#### **Notice of Intent**

**Sundry ID: 2837006**

Type of Action: APD Change

**Procedure Description:** Devon Energy Production Co., L.P. (Devon) respectfully requests to change the drilling plan to 4 string design for the Ross Draw 35-26-23 Fed Com 410H (APD ID 10400097200), 414H (APD ID 10400096593) and 424H (APD ID 10400096592) wells. Please see attachments. Batch sundry to only include attachments by pad for the drilling plan for the deepest well (TVD).

#### **Section 2 - Blowout Preventer Testing Procedure**

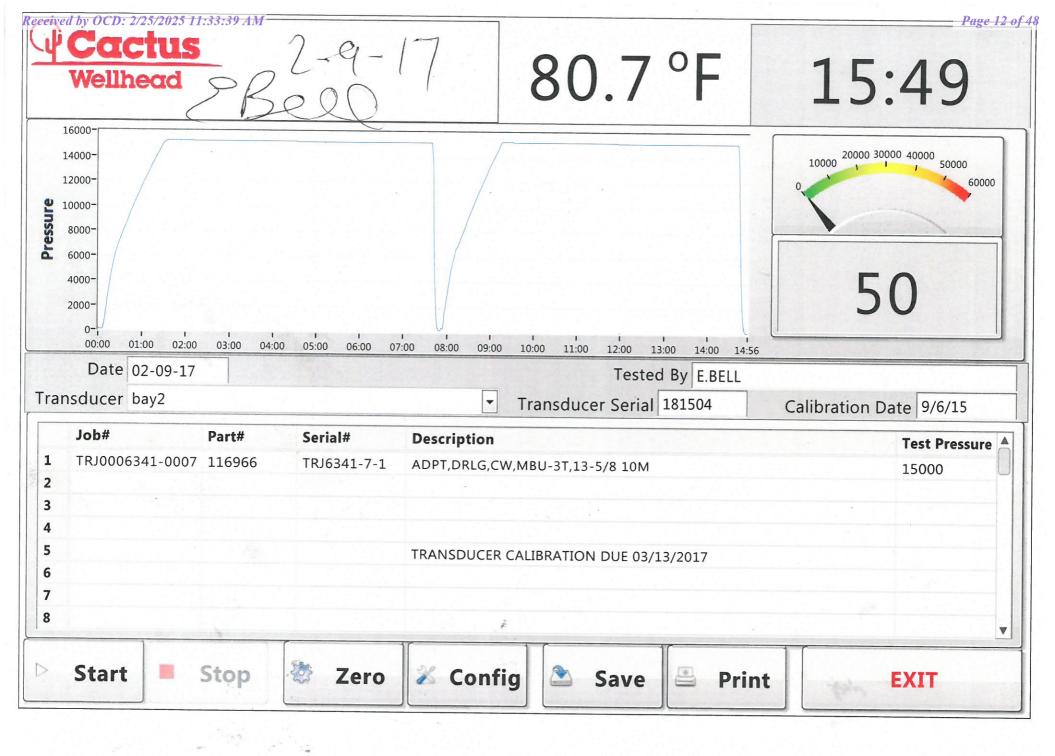
Devon Energy requests to only test BOP connection breaks after drilling out of surface casing and while skidding between wells which conforms to API Standard 53 and industry standards. The initial BOP test will follow 43 CFR 3172, and subsequent tests following a skid will only test connections that are broken. This test will at minimum include the Top Pipe Ram, HCR, Kill Line Check Valve, QDC (quick disconnect to wellhead) and BOP shell of the 10M BOPE to 5M for 10 minutes. Additional pressure testing is required for pressure-containing and pressure-controlling connections when the integrity of a pressure seal is broken. If a break to the flex hose that runs to the choke manifold is required due to repositioning from a skid, the HCR will remain open during the shell test to include that additional break. The variance only pertains to intermediate hole-sections. This variance will meet or exceed 43 CFR 3172 per the following: Devon Energy will perform a full BOP test per 43 CFR 3172 before drilling out of the intermediate casing string(s) and starting the production hole, testing the Annular during initial BOP testing to a minimum of 70% RWP and higher than MASP, and pressure testing at a 21-day interval frequency. The BLM will be contacted 4hrs prior to a BOPE test. The BLM will be notified if and when a well control event is encountered. In the event break testing is not utilized, then a full BOPE test would be conducted.

Devon Energy requests to perform offline BOP stump testing and offline BOPE testing. All pressure-containing and pressure-controlling seals will be tested either online or offline as denoted in the table below and per BLM approval during initial BOP test following test pressure requirements set forth in 43 CFR 3172. Remaining components not tested offline or on the stump will be tested within 72-hours when the BOP is connected to the wellhead. If stump testing exceeds 72-hour window prior to connecting to the wellhead, the BLM will be notified and either stump testing restarted, or the BOP being tested online. The BLM will be contacted 4hrs prior to a BOPE test. The BLM will be notified if and when a well control event is encountered. In the event stump testing is not utilized, then a full BOPE test would be conducted.

Components	Offline	Offline, BOPE	Break	Online
Upper Rams		X	Х	X
Blind Rams		X		X
Lower Rams				X
Outside Kill Valve		X	X	X
Inside Kill Valve		X	X	X
Kill Line Check Valve		X	X	X
Inside Choke Valve		X	X	Х
HCR		X	X	Х
Kill Line	X			X
Annular		Х		Х
Choke Manifold Valves and Hose	Χ			X
Mudline (Mud Pumps, Rig Floor Valves, Kelly Hose, Mud Line)	Х			Х
Standpipe Valve	Х			Х
IBOP (Upper and Lower)	X			X

Devon requests offline BOPE testing for the following components: Upper Rams, Blind Rams, Kill Valves, Choke Valves, and Annular Remaining well control equipment components will either be tested offline or online, per BLM approval

Remaining BOPE will be tested online within 72-hours form completing the offline BOPE component testing

Notify the BLM if the online BOPE testing exceeds 72-hours

All Full Tests not completed "Offline" or "Offline, BOPE" are required to be complete Online

Devon requests Break testing as stated above for 5K tests, not including production hole

$Annular\ Preventer\ will\ be\ tested\ to\ minimum\ of\ 70\%\ RWP\ and\ higher\ than\ MASP\ during\ initial\ BOP\ test$

Pressure testing is required for pressure-containing connections if the integrity of a pressure seal is broken during a break test Full Tests required when entering production hole
